**EMPIRE LUMBER MIXED-USE PROJECT**  
**RESPONSE TO COMMENTS**

The Empire Lumber Mixed-Use Project Initial Study and Mitigated Negative Declaration (IS/MND) was prepared and evaluated in compliance with the requirements of CEQA. The IS/MND was circulated for 27 days from December 18, 2020 to January 13, 2021. The City received nine comment letters during the public comment period:

**FIGURE 4.16-2 (Revised)**

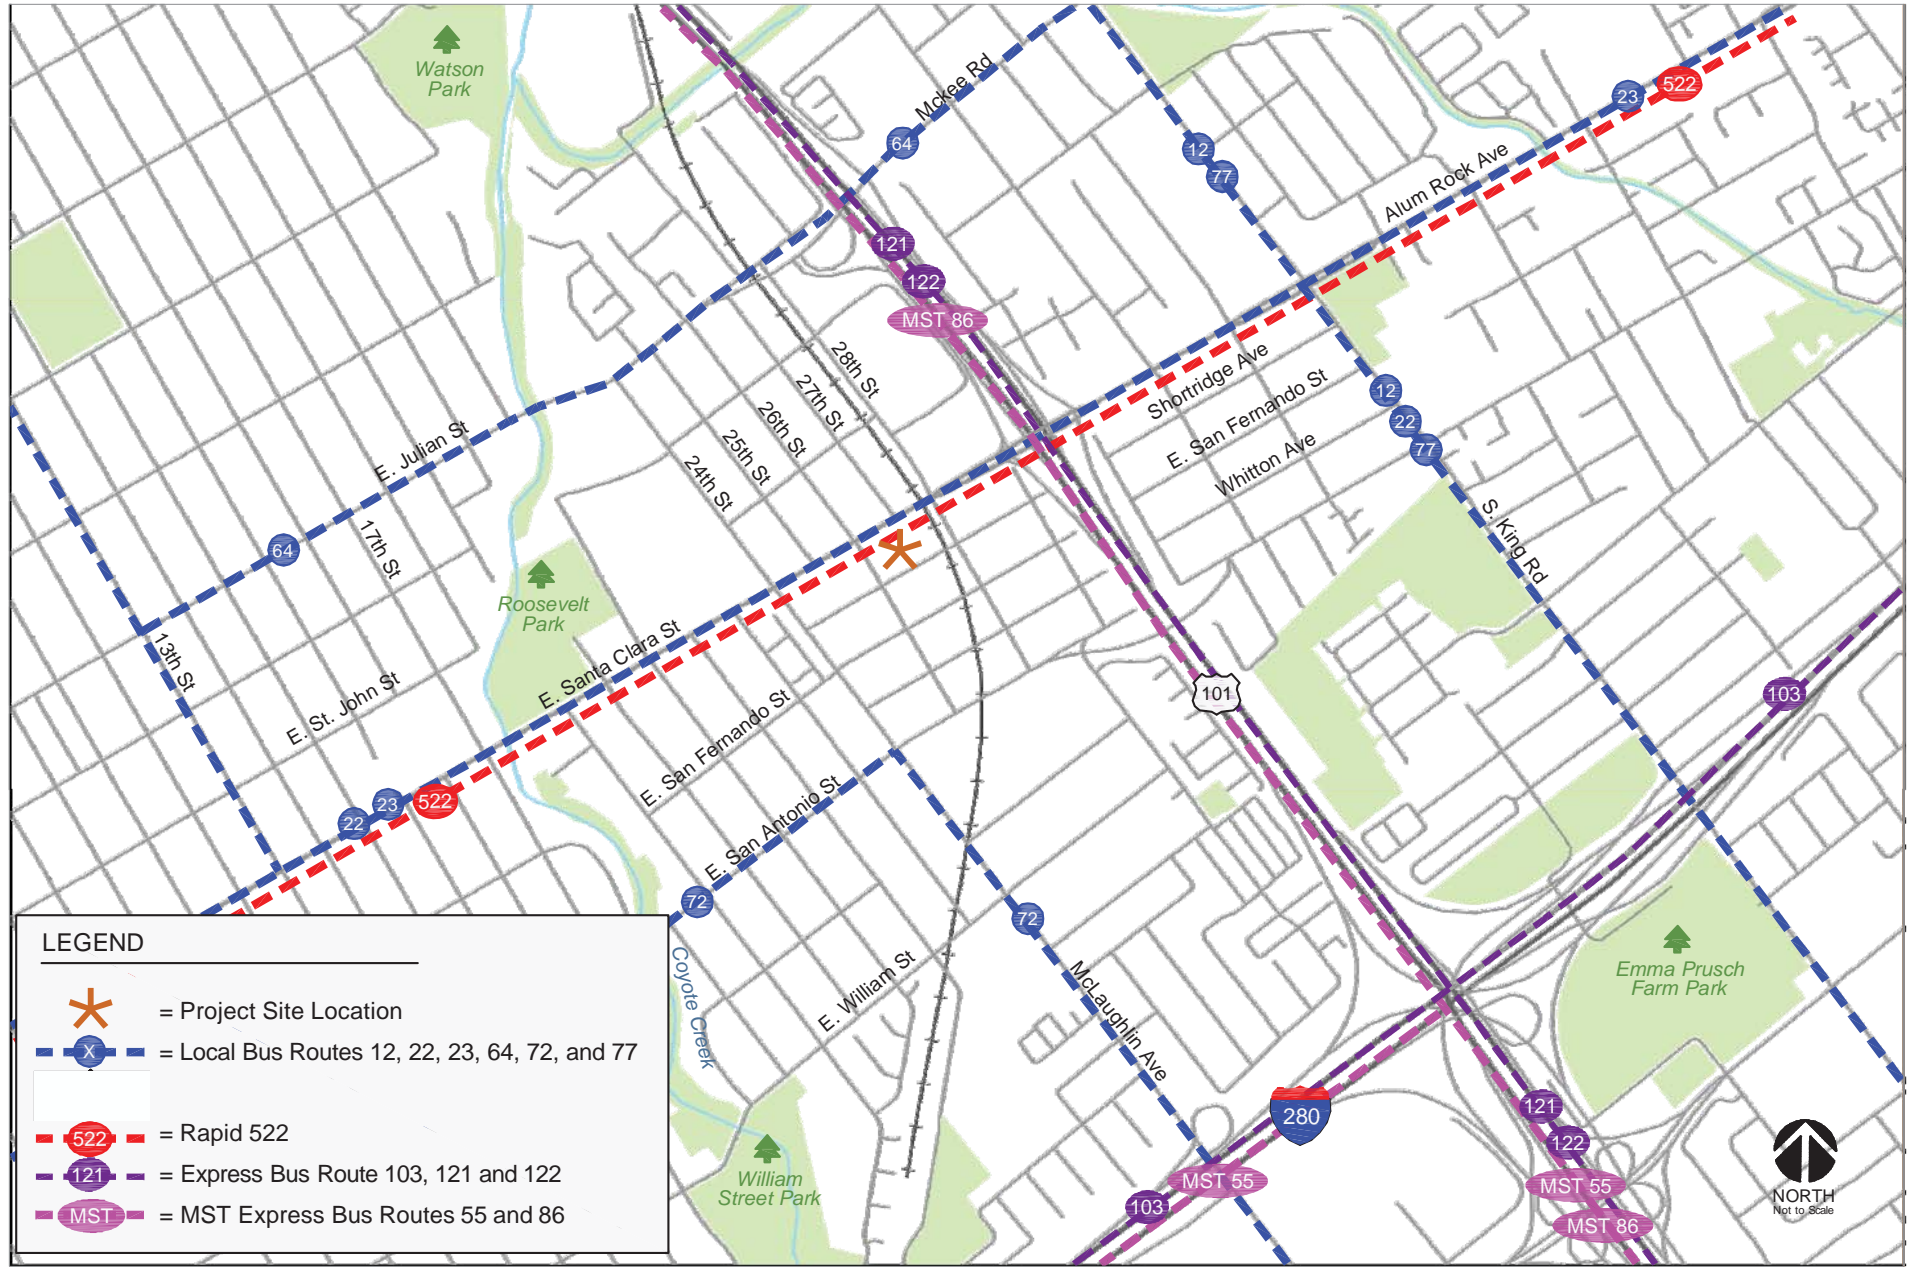
Figure 4.17-2 should provide updated route naming. VTA does not have a “community” bus route.

**Response A-6:** Figure 4.17-2 has been revised to remove reference to Community Route 66. The revised figure is attached to this memo.

ROADWAY PLAN AND PROFILE  
STA 211+00 TO STA 301+00  
24TH STATION

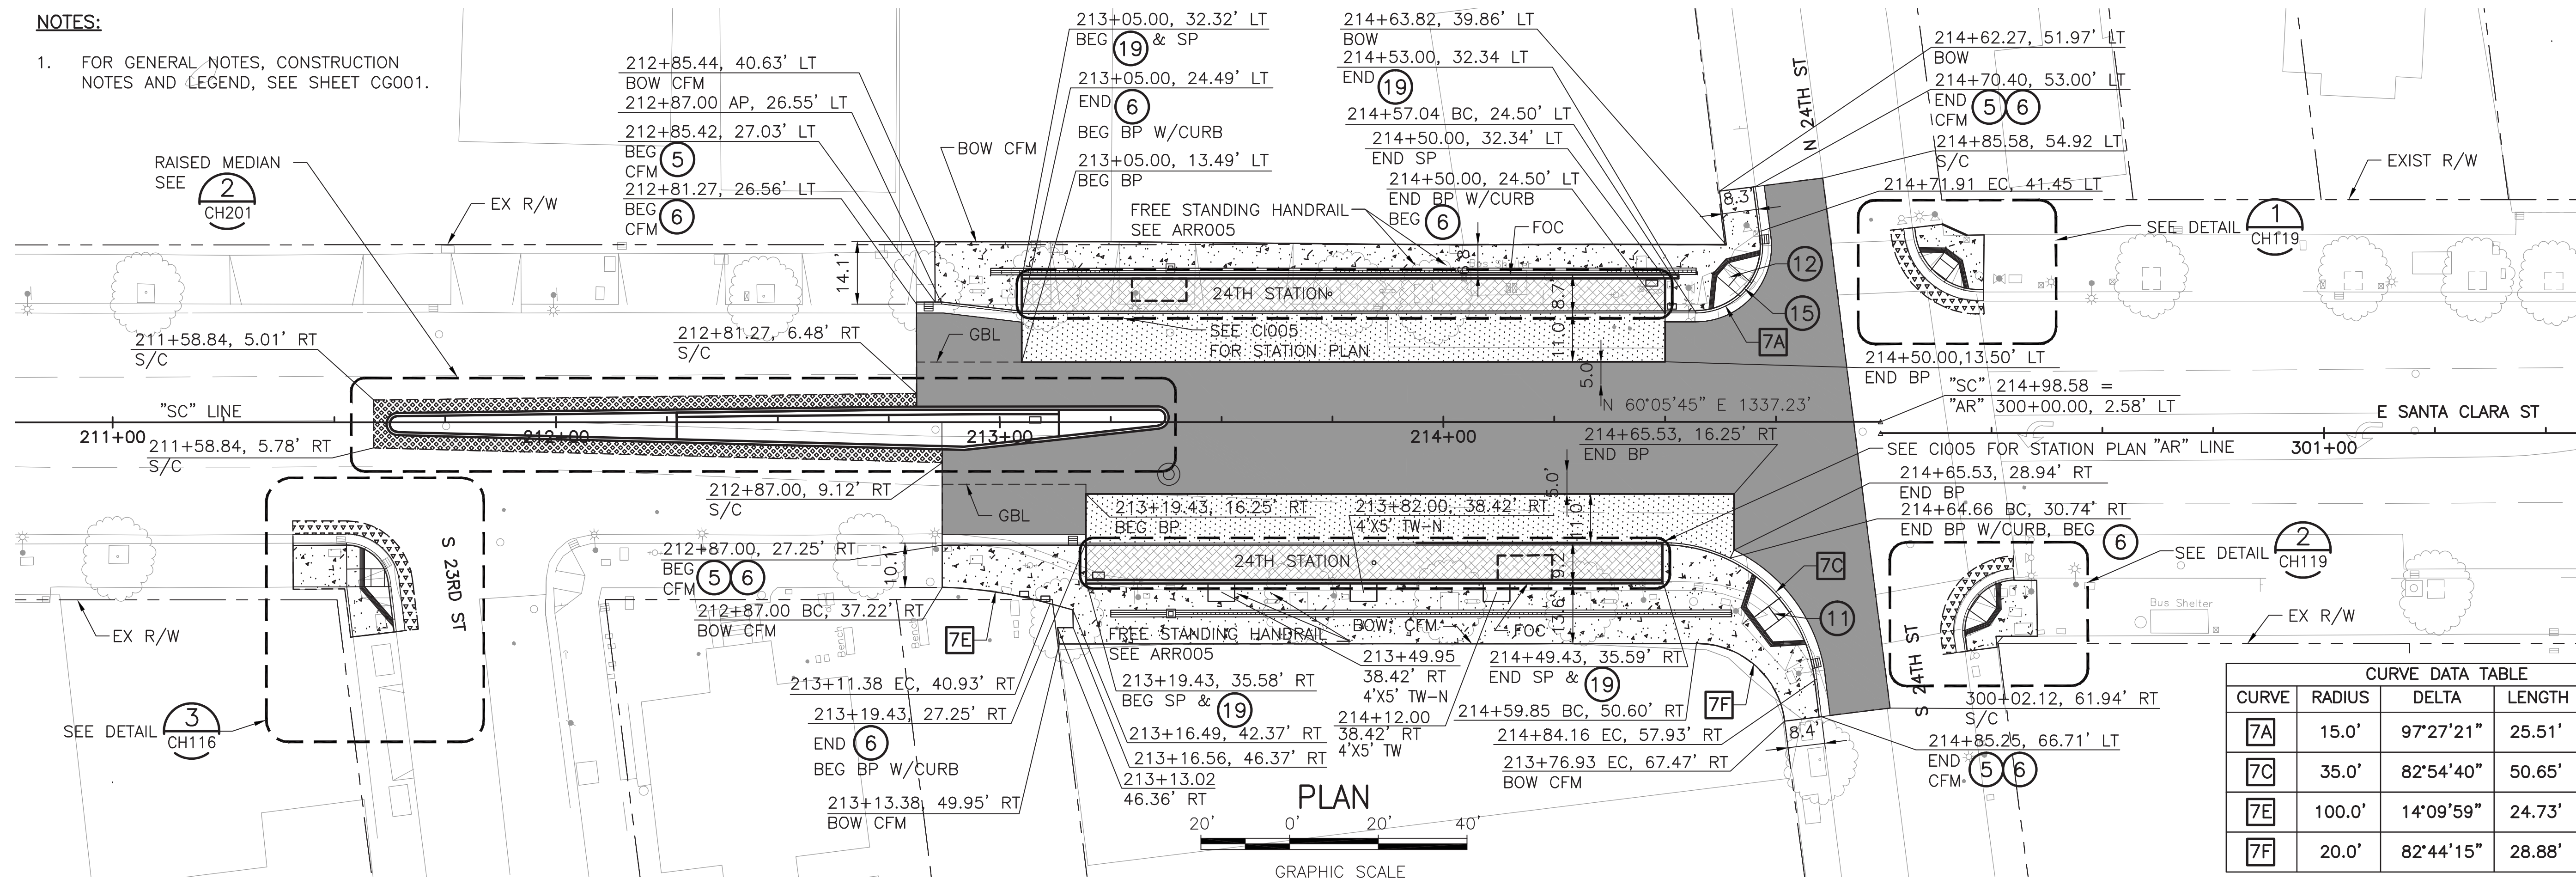
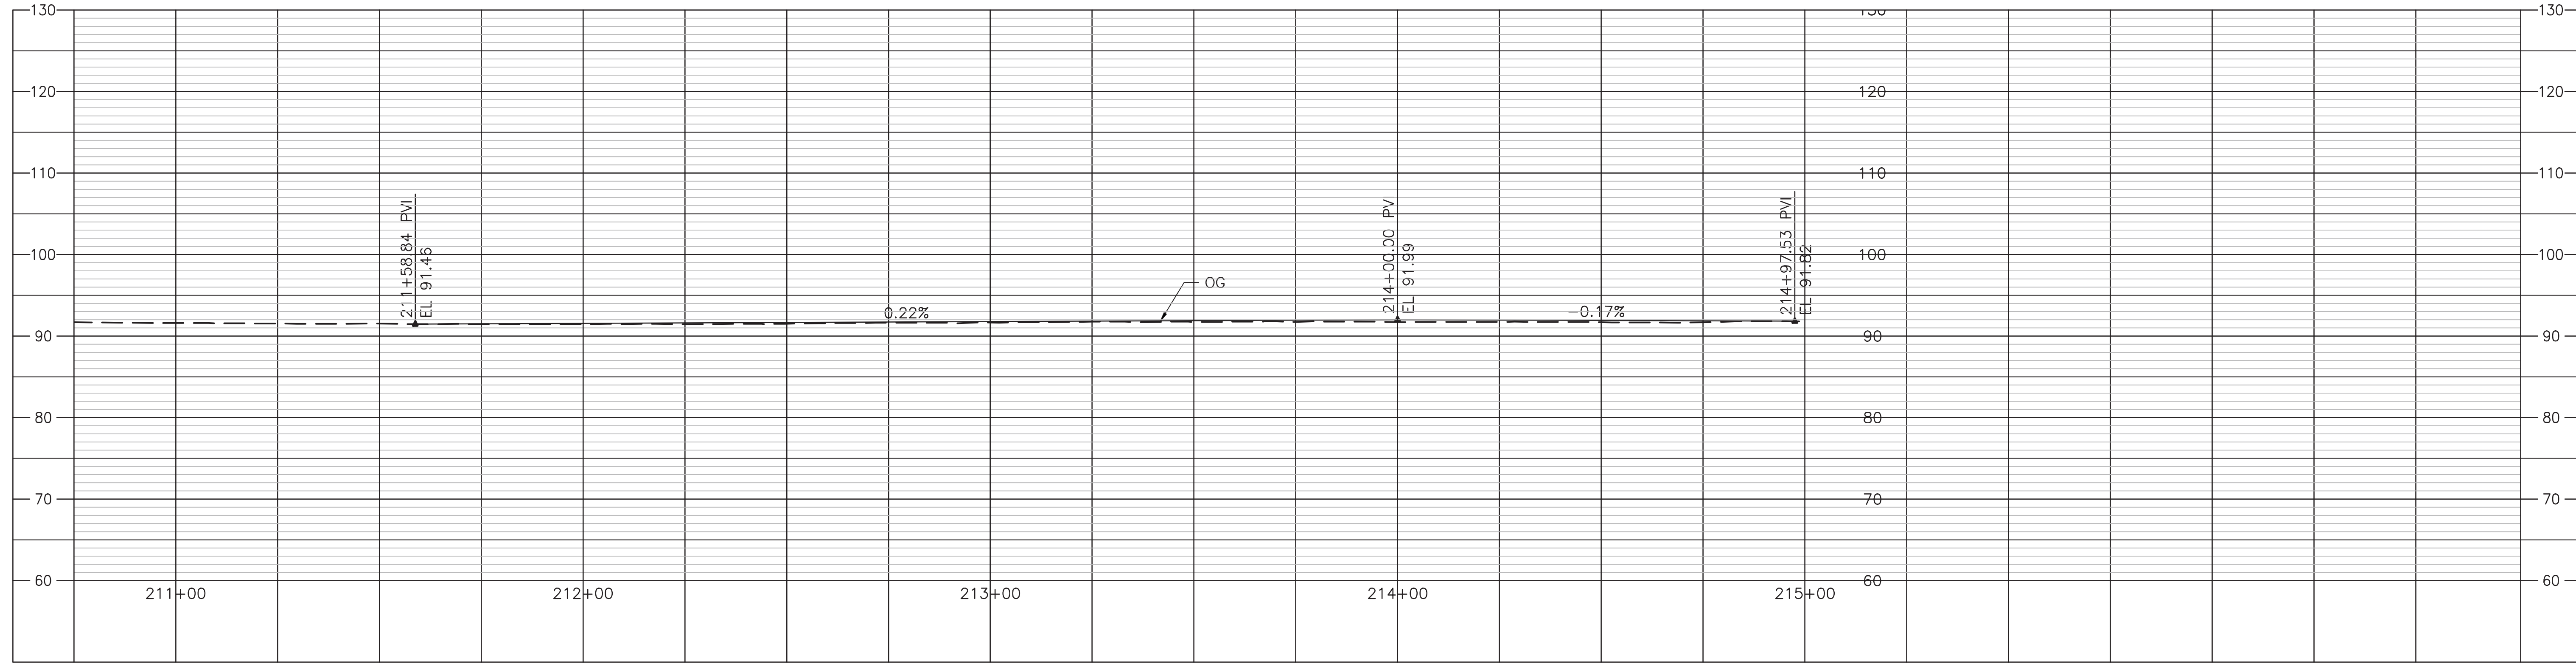
The Project Initial Study (page 161) concludes that the Project “would not...conflict with the operation of existing or planned facilities.” The site plan (Figure 3.2-1) and conceptual site plan (Appendix F, page 3) should be redrawn to reflect a relocated BRT station along the Project frontage for the Final IS/MND. It is not apparent from the Initial Study if any assessment occurred to determine if a “planned” 28<sup>th</sup> Street Station could be relocated to the frontage plaza. VTA previously provided a detail, attached again, that provides dimensions for existing BRT side running station. These dimensions should be used to determine if any conflicts present themselves. The East San José Multimodal Transportation Improvement Plan also documents a relocated BRT station along the project frontage (Appendix F, Figure 20, page 56).

If the station dimension encroaches into the pedestrian plaza, beyond the public ROW, an easement should be conditioned upon approval to provide future access for temporary construction and permanent placement of a the 28<sup>th</sup> Street Station along the project frontage.

**Response A-1:** The City has reviewed the conceptual plans for the East San José Multimodal Transportation Improvement Plan in conjunction with the site plans and concluded there is sufficient right-of-way provided for the future BRT station. Therefore, an easement is not required by the project.
